Technical Service Bulletin: TSB250205

Belt Guard Noise

- QST30 CM552

Figure 1, Capscrew Assembly with Three Mounting Locations

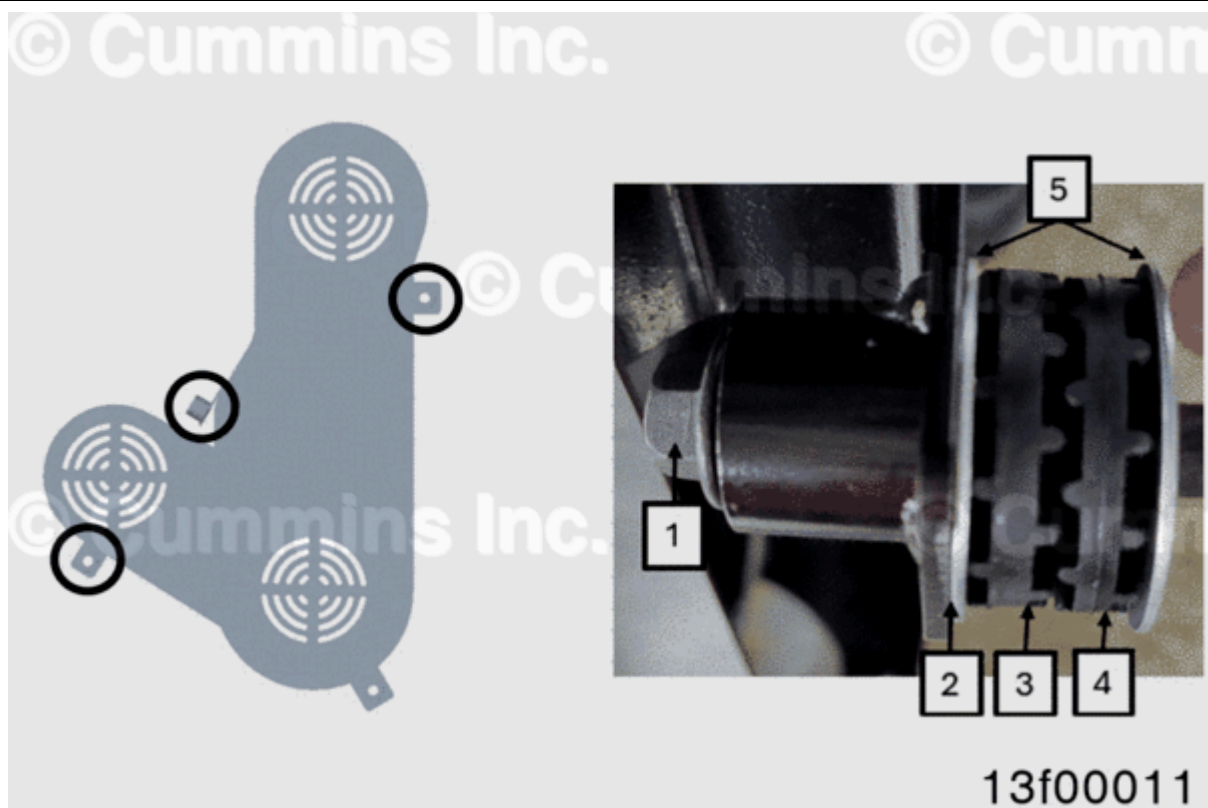
1. Install the capscrew assemblies onto the belt guard. The components **must** be in the order shown.

Three mounting locations will each use:

1. Part Number 3093807 – capscrew – quantity 1
2. Part Number 3643019 – retaining ring – quantity 1
(**Not** visible in picture, located between bracket and first washer)
3. Part Number 3035083 – vibration isolator – quantity 1
4. Part Number 3035084 – vibration isolator – quantity 1
5. Part Number 3033800 – washer – quantity 2

Figure 2, Capscrew Assembly with One Mounting Location

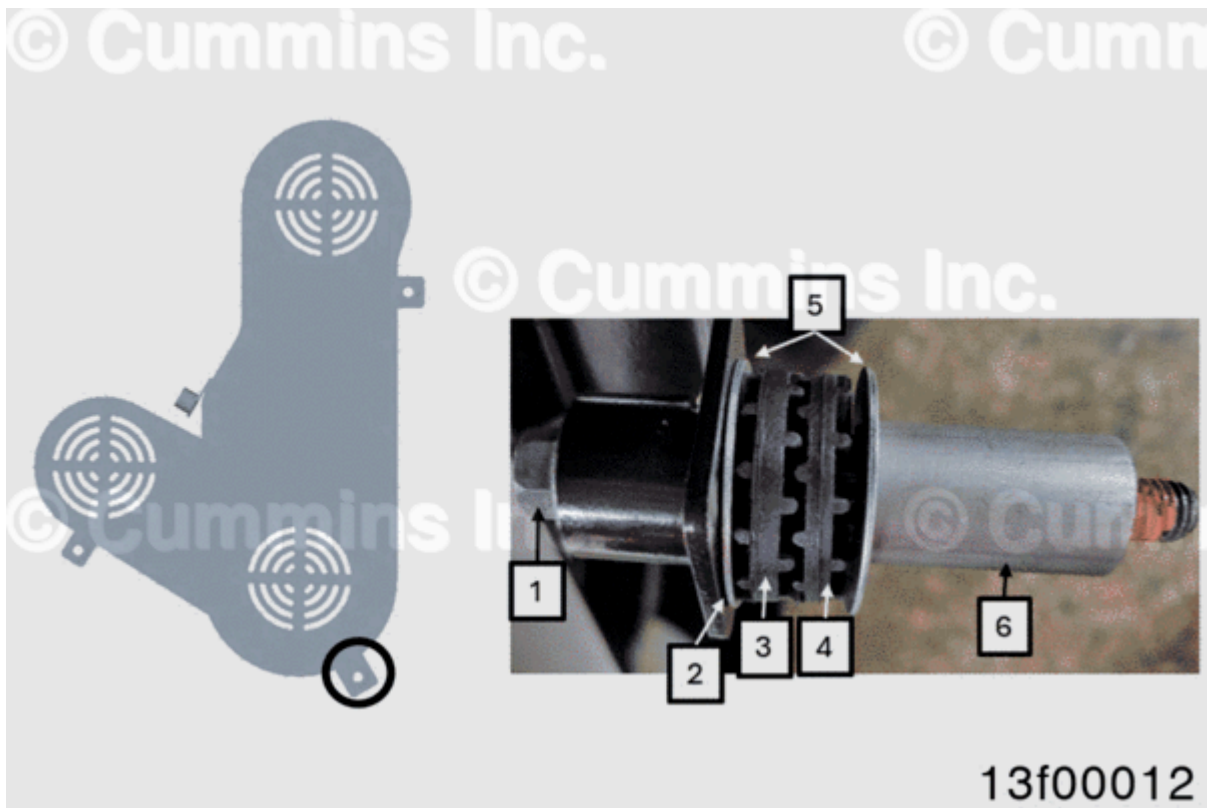
One mounting location (bottom) will use:

1. Part Number 3641716 – capscrew – quantity 1
2. Part Number 3643019 – retaining ring – quantity 1
(**Not** visible in picture, located between bracket and first washer)
3. Part Number 3035083 – vibration isolator – quantity 1
4. Part Number 3035084 – vibration isolator – quantity 1
5. Part Number 3033800 – washer – quantity 2
6. Part Number 3072999 – spacer – quantity 1

2. Apply Loctite to capscrews.
3. Install the belt guard.
4. Tighten the capscrew assemblies until the distance between the washers is 9.5 mm [0.37 in].
